SUBJECT: CATAWBA NUCLEAR STATION, UNIT 2 RE: ISSUANCE OF AMENDMENT
COLD LEG ELBOW TAP FLOW COEFFICIENTS (TAC NO. MB6529)

Amendment No. 199
License No. NPF-52

SAFETY EVALUATION BY THE OFFICE OF NUCLEAR REACTOR REGULATION
RELATED TO AMENDMENT NO. 199 TO FACILITY OPERATING LICENSE NPF-52

CATAWBA NUCLEAR STATION, UNIT 2

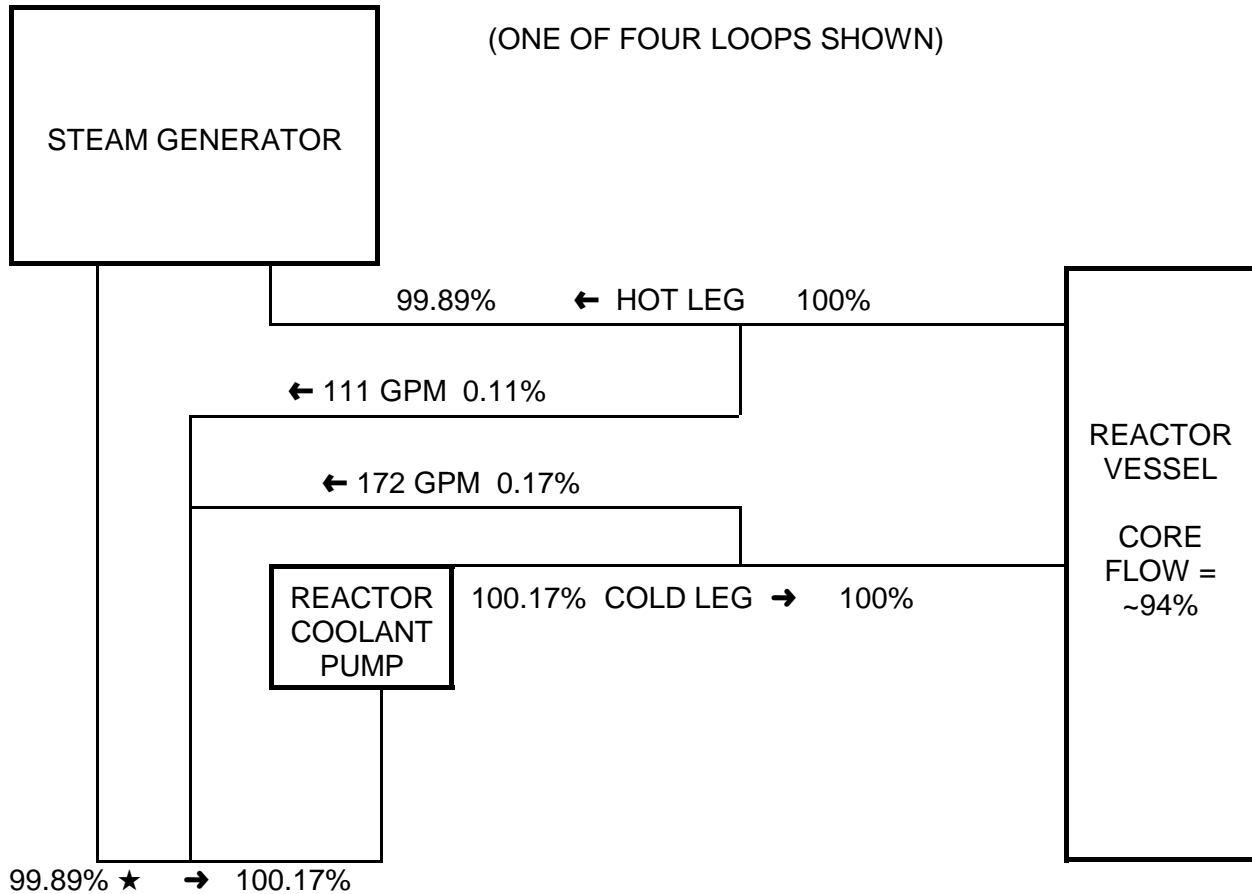
The licensee stated that the boric acid effect is straight-forward, but only contributes to a 200 gpm flow rate change during a fuel cycle, with the flow rate decreasing during the cycle. Another contributor to in-cycle flow variation, as identified in Reference 2, is the flow rate decrease due to apparent buildup of crud on the fuel assemblies. As noted in the table in Section 3.2.1 above, the total in-cycle variability due to these effects is about 700 gpm. The staff judged these effects to be sufficiently small that they would not change any review conclusions. Further, they are not included in the analytical model since there is no attempt to include variations within a cycle. The staff finds the licensee's approach to neglecting variations during a fuel cycle to be acceptable. However, the staff notes that this effect is a potential contributor to uncertainty when comparing analytical model predictions to operational data, and the uncertainty can be reduced by correcting for the approximate effect of the time during a cycle when operational data are obtained.

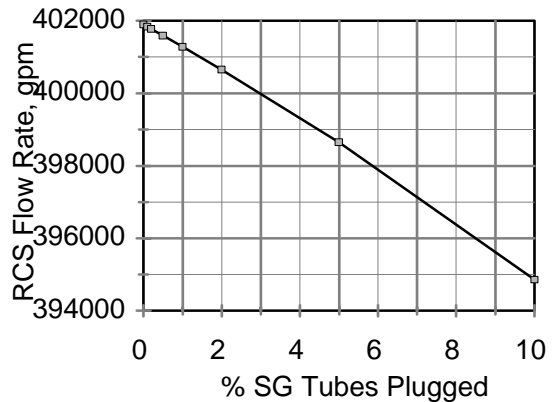
As shown in the table above, the staff calculated a total RCS flow rate of 401,472 gpm that is 346 gpm smaller than the licensee’s calculated flow rate of 401,818 gpm. For the July 1986 case, the staff calculated a flow rate that is 345 gpm smaller than the licensee’s flow rate. Differences in flow rate between four loops shown above are considered to be due to steam generator tube plugging. Since these differences are small, they may be neglected.

Differences in values due to removal of RTD manifolds are small in comparison to the conservatism the licensee introduced into its elbow tap flow coefficient determination. Consequently, the staff has neglected these perturbations in reaching its conclusions. Similarly, the staff finds that the corrections to the analytical model identified in Reference 4 also will not affect its conclusions.

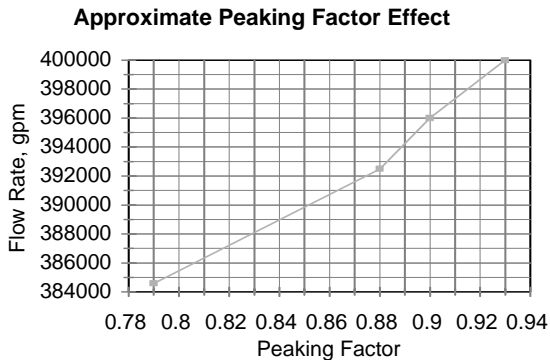
The graph shows that there is a steady upward trend in flow rate as the peaking factor approaches a value of 1.0. A value of 1.0 would represent a flat reactor core power profile for which no thermal streaming would be expected. Similar behavior will be obtained for any reasonable assumption regarding the effective reduction in peaking factor due to the better thermal sampling with RTD manifolds installed. This illustrates that there is no significant evidence of a non-conservative perturbation associated with thermal streaming during early plant operation.

The same conclusion can be reached by assuming the early flow rate perturbations have diminished after the first three data points in the licensee's Figure 2 of Reference 2, and by extrapolating the fourth and later points back to initiation of plant operation.

On the basis of this evaluation and the licensee's arguments, the staff concludes that there is no significant evidence of a non-conservative perturbation associated with thermal streaming being introduced during early plant operation and that this issue is resolved.

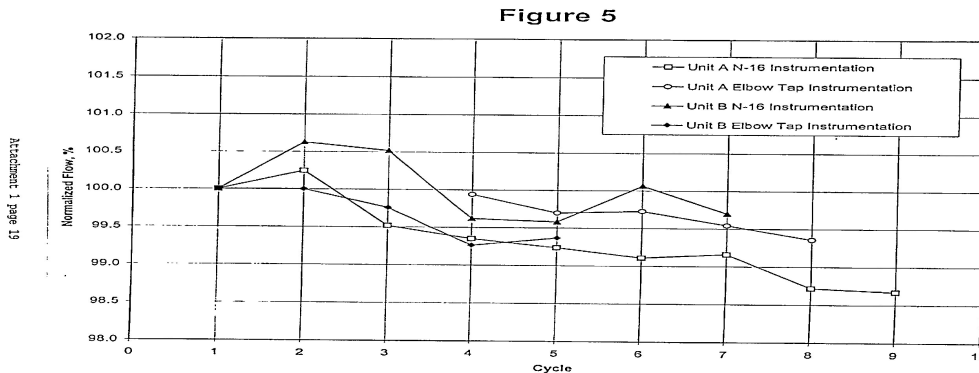
The licensee has previously provided qualitative discussions covering long-term behavior. Reference [6] states that "The 11 year flow comparison (at Prairie Island) showed that the average difference between elbow taps and LEFMs was less than 0.3% flow," and we obtained similar differences in [our] comparison. On this basis, and with consideration of the above information, we conclude that the elbow coefficients can be assumed constant for the operating cycle scheduled to begin in October, 2001.

This information also applies to the licensee's amendment request of Reference 2 since there is nothing that limits its consideration to only one operating cycle. In Reference 2, the licensee reported that it had been unsuccessful in obtaining additional LEFM data.

Although limited in scope, the LEFM information provided by the licensee provides support for a conclusion that elbow tap flow coefficients remain constant in long-term operation.

Attachment 1 page 13

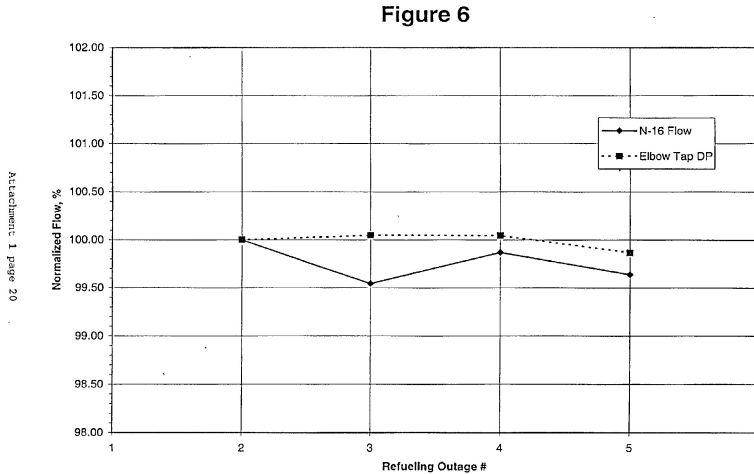
The licensee's Figure 5 from Reference 2, reproduced below, provides data for two plants identified as Units A and B. The Unit A data for Cycles 4 through 8 shows similar downward flow rate trends for the N-16 and elbow tap instrument data with a relatively consistent offset ranging from 0.4 percent to 0.7 percent. The Unit B data for Cycles 1 through 5 shows somewhat more variation, with the N-16 and elbow tap data coming closer together with additional cycles. The licensee attributed the N-16 fluctuations to the uncertainty band in the instrumentation, but did not provide substantiation for this conclusion other than to note the flow rate increases at Cycles 2 and 6 could not be attributed to real flow increases, and therefore, could be attributed to measurement process variation. Examination shows that the elbow tap indications appear to be more stable. Overall, there is no indication of a long-term change in the elbow tap indications, in comparison to the N-16 indications, and the limited data for Unit A generally substantiates that the elbow tap flow coefficients remain constant.

Reference 4 provided the following Figure 1 that the staff finds to be particularly informative:

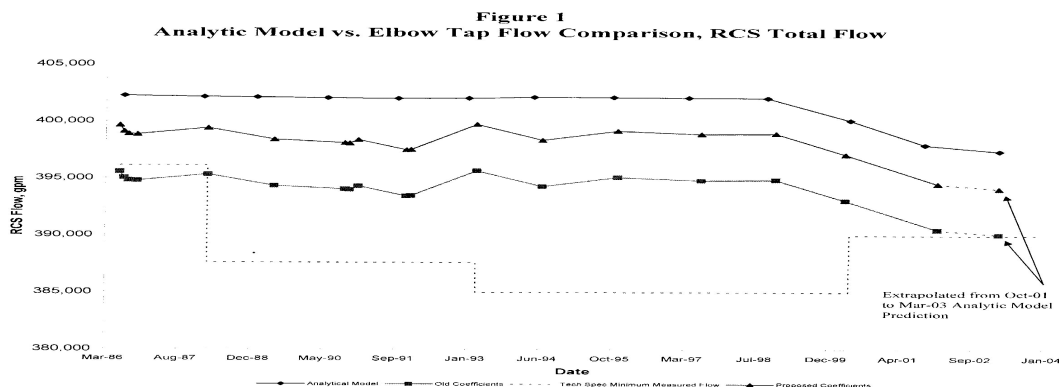
The analytical model predicts almost no change in RCS flow rate until loading of RFA fuel in 1998, consistent with the staff's discussion in Section 3.2.2.6, above. The elbow tap flow rates show a general decrease in flow rate until loading of Mark-BW fuel in 1991 with a flow rate recovery to roughly the original value with a full core of Mark-BW fuel in 1995. After 1995, there is excellent agreement between the analytical model and the elbow tap flow rates, with a constant offset that the staff believes reflects the conservatism the licensee introduced through the calorimetric determinations of the elbow tap flow coefficient. It is interesting to note that the licensee changed to Rosemount transmitters in 1994 (discussed in Reference 4) and changed its transmitter scaling to be consistent throughout the data processing process. Further, 1993 is the time at which the licensee identified scaling problems. Consequently, the staff places a high reliance on the post-1995 elbow tap behavior. The staff further notes that an elbow tap coefficient change would be manifested by a change in the difference between the elbow tap and analytical model flow rates. No such change is evident in the August 1987 and post-1994 data. Consequently, the staff concludes that the licensee's Figure 1 shows there is no long-term change in the elbow tap flow coefficients.
